ADDENDUM #1
Issued February 27, 202
Bid #29-20
Annual Paving and Roadwork Project

This Addendum forms part of the original document marked “**Bid 29-20 Annual Paving and Roadwork**”.

FOR: Bow Street Sidewalk Improvements
 Portsmouth, NH

C-101

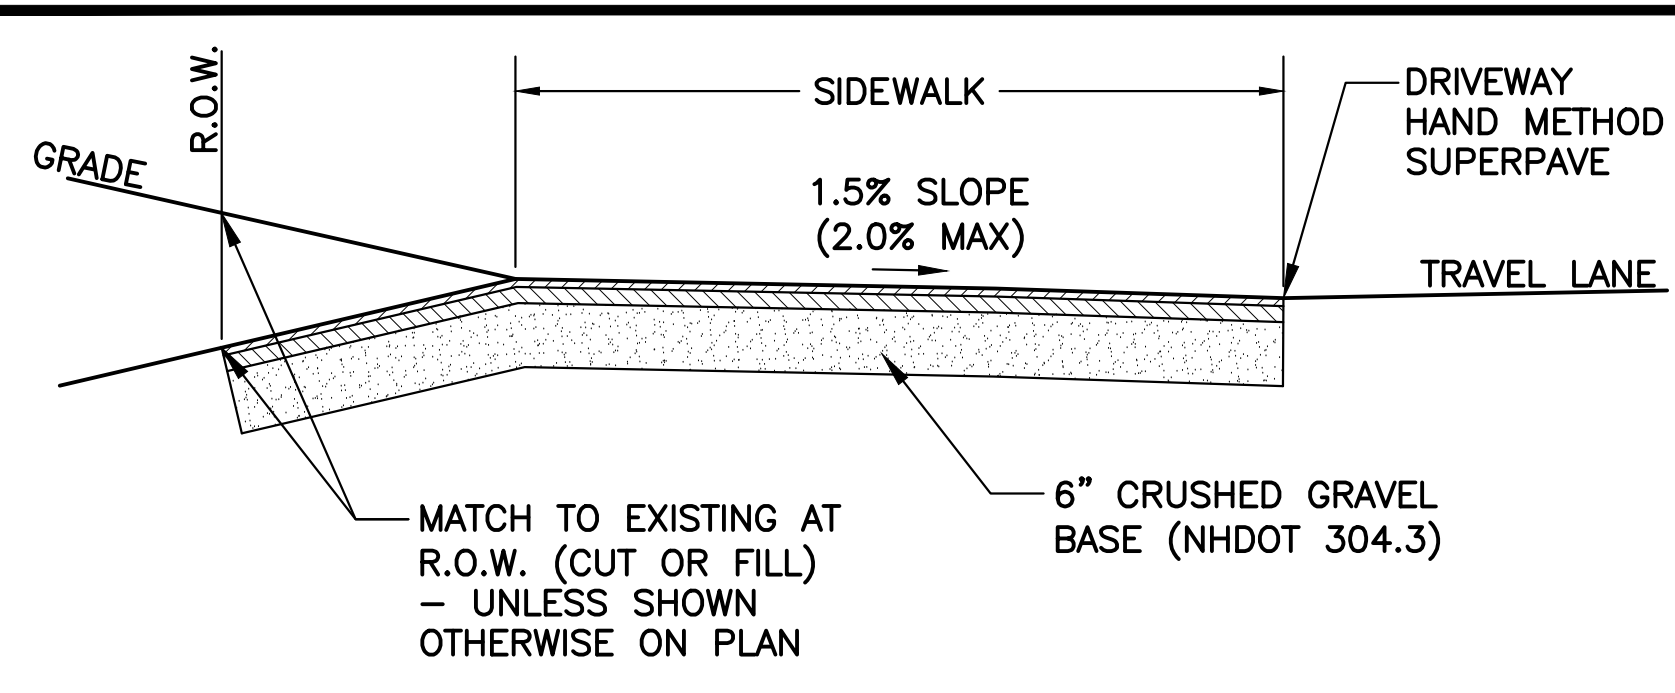
Can we get some clarification regarding the sidewalk work on Bow St?

Attached, please find a small plan set regarding Bow St. Some of the sidewalk work will require coordination with private property owners. The City is still in the process of negotiating and coordinating with the owners at this time. If the effort to involve the different private parties fails, some portions of the work shown on the plans may be excluded from the final project. Also, as shown on the plan set, a small section of Bow St will need to be lowered. The limits of work and the method to lower the road will likely need to be determined onsite once existing pavement thickness is determined.
